City of Bristol
Zoning Commission

REGULAR MEETING - MONDAY, JANUARY 13, 2025
CITY HALL COUNCIL CHAMBERS
111 NORTH MAIN STREET
6:00 P.M.

- a. Application #2512 – Special Permit for a Unified Residential Development (15 units) at Earl Street, east of Crown Street and west of Melrose Street; Assessor's Map 14, Lots 72-71, 73-70, 74-69, 75-68 & 76-67 Earl Street; R-15/RM (Single Family Residential/Mixed Residential Overlay) zone; DGG Development, LLC, applicant.

- b. Application #2513 – Site Plan for a Unified Residential Development (15 units) at Earl Street, east of Crown Street and west of Melrose Street; Assessor's Map 14, Lots 72-71, 73-70, 74-69, 75-68 & 76-67 Earl Street; R-15/RM (Single Family Residential/Mixed Residential Overlay) zone; DGG Development, LLC, applicant.

ASSESSOR'S MAP/LOT:	14/72/71, 14/73/70, 14/74/69, 14/75/68 & 14/76/67	DRAWING NO.	GRA-001
DRAWING TITLE:	GRADING PLAN	SHEET NO.	7

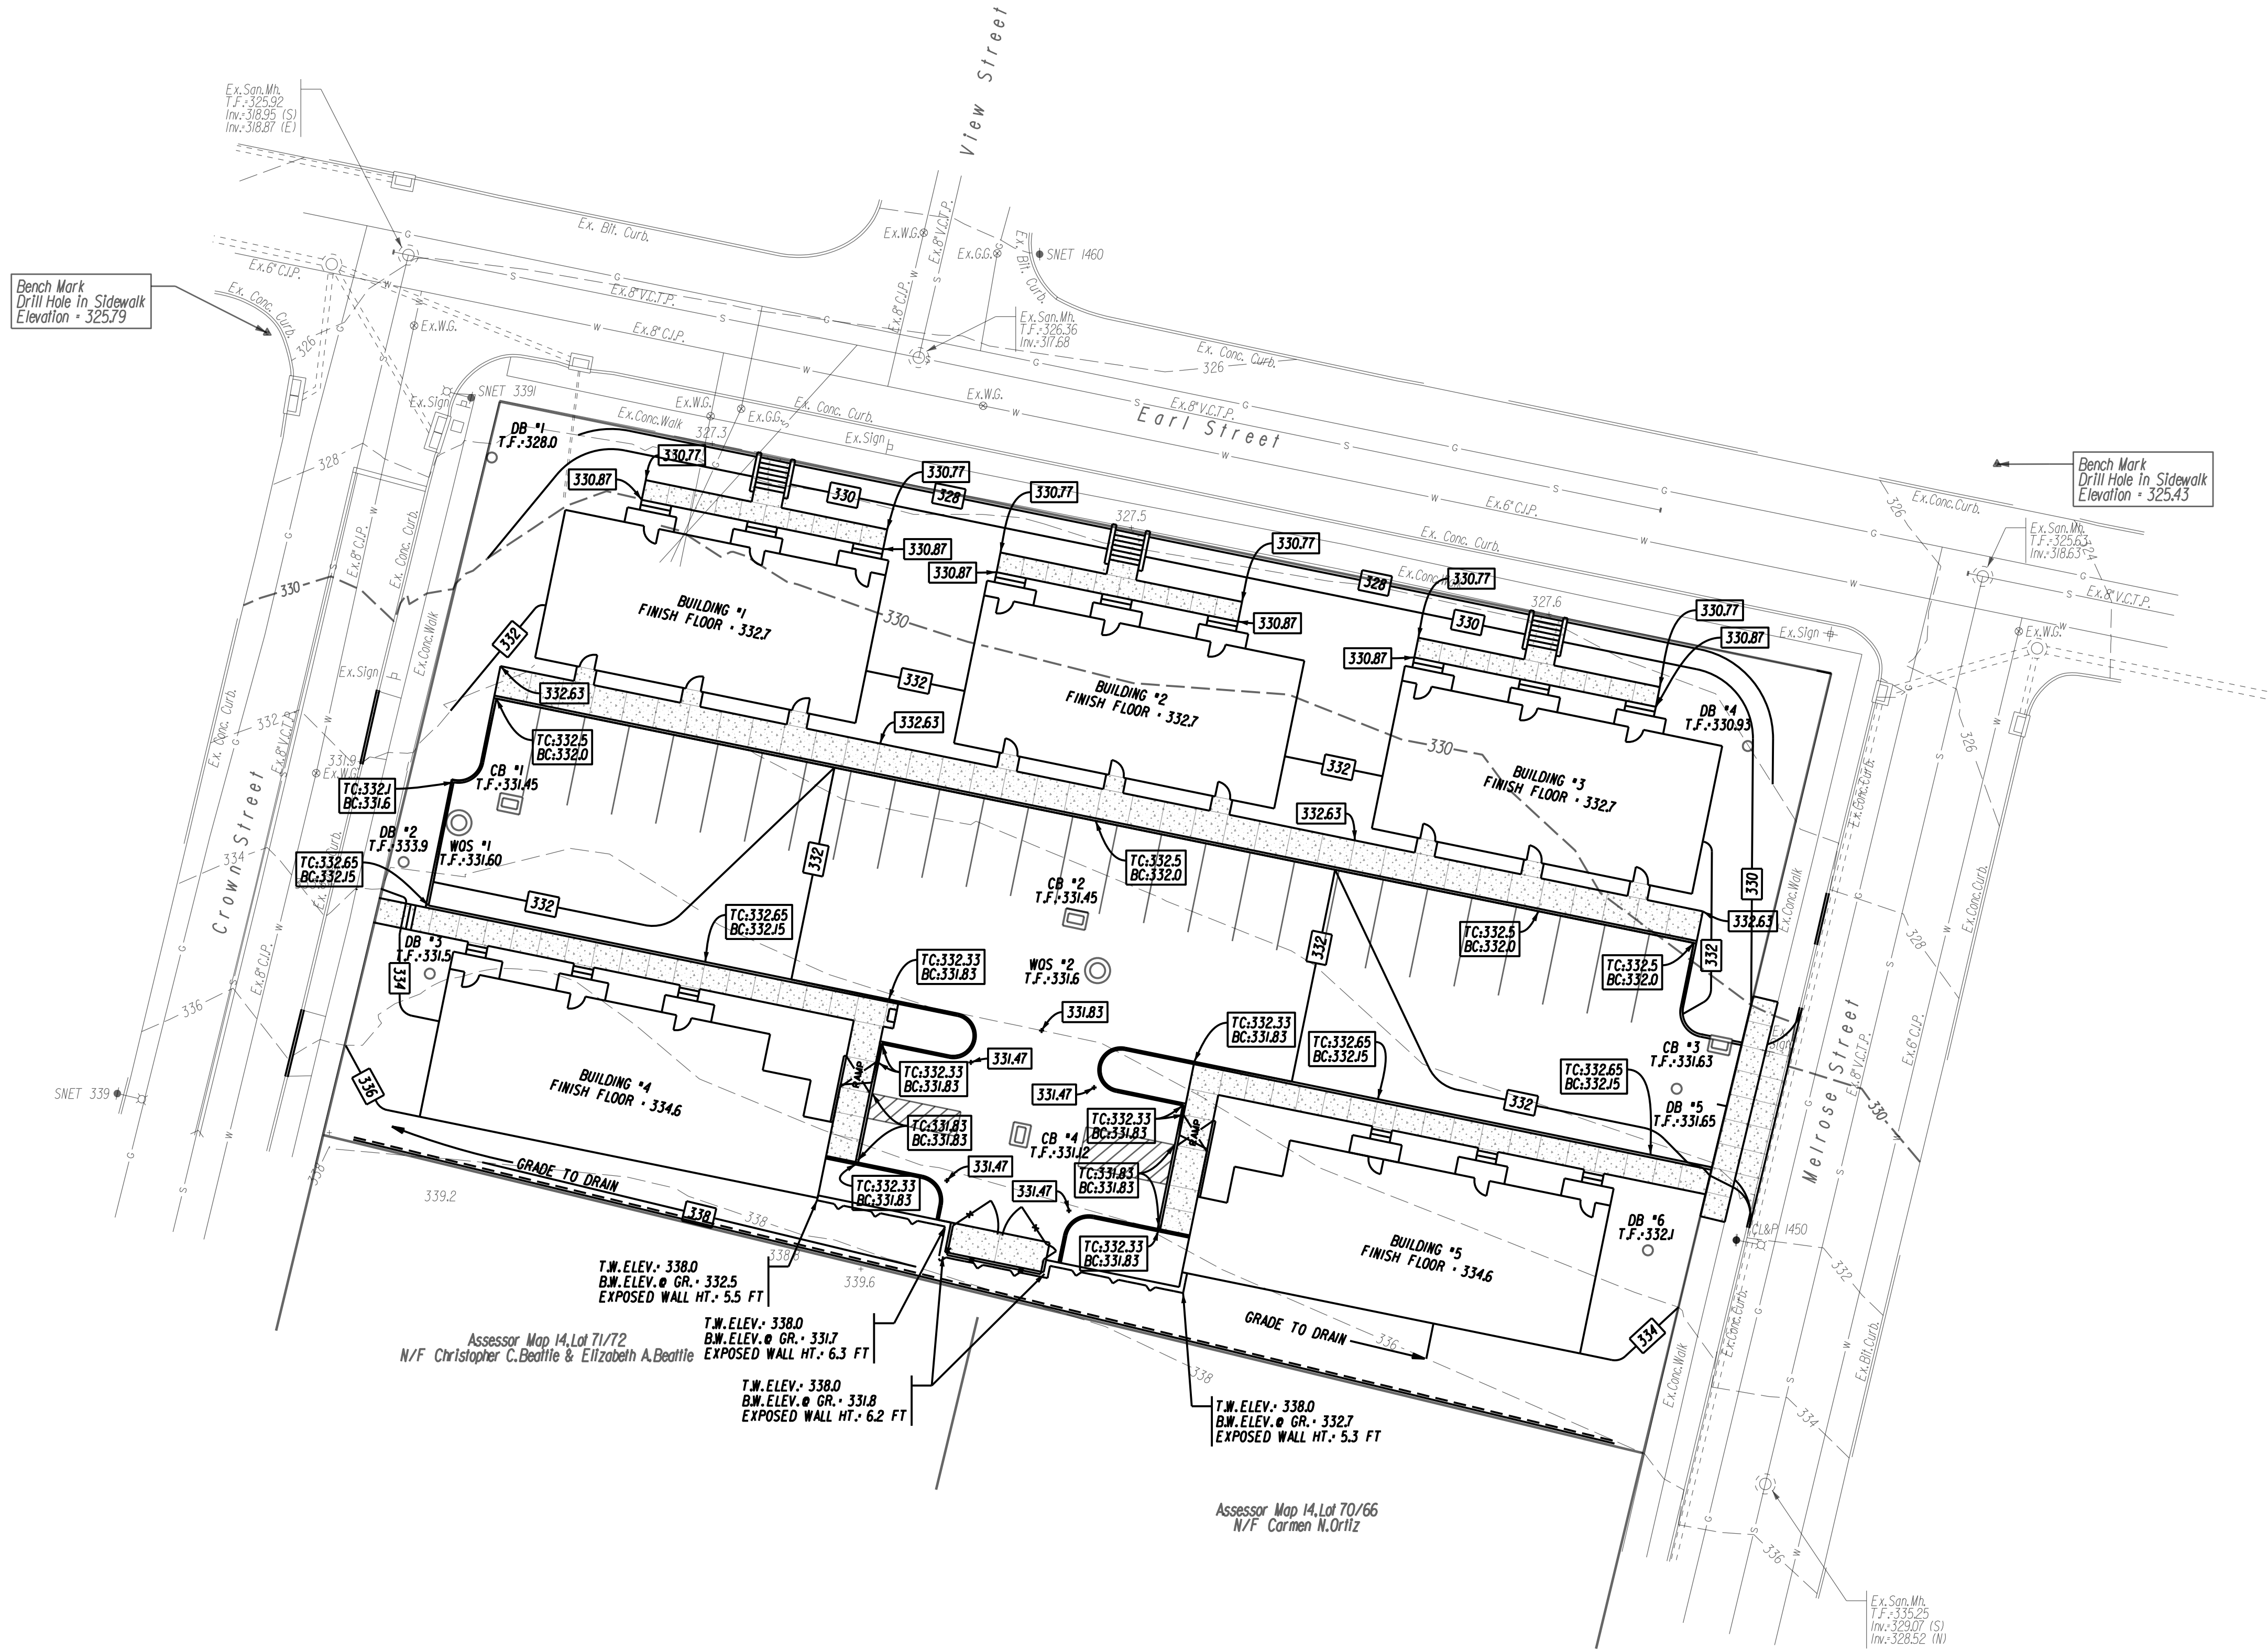
8/21/24 City Response: *There seems to be a missing 330 contour on the grading plan (sheet 7) along Earl Street, there also seems to be some drainage features along Earl Street that might have been turned off in the electronic document.*

11/6/24 Applicant Response: See attached revised sheet 6 Drainage and Utilities Plan and revised sheet 7 Grading Plan, that have the missing items turned on.
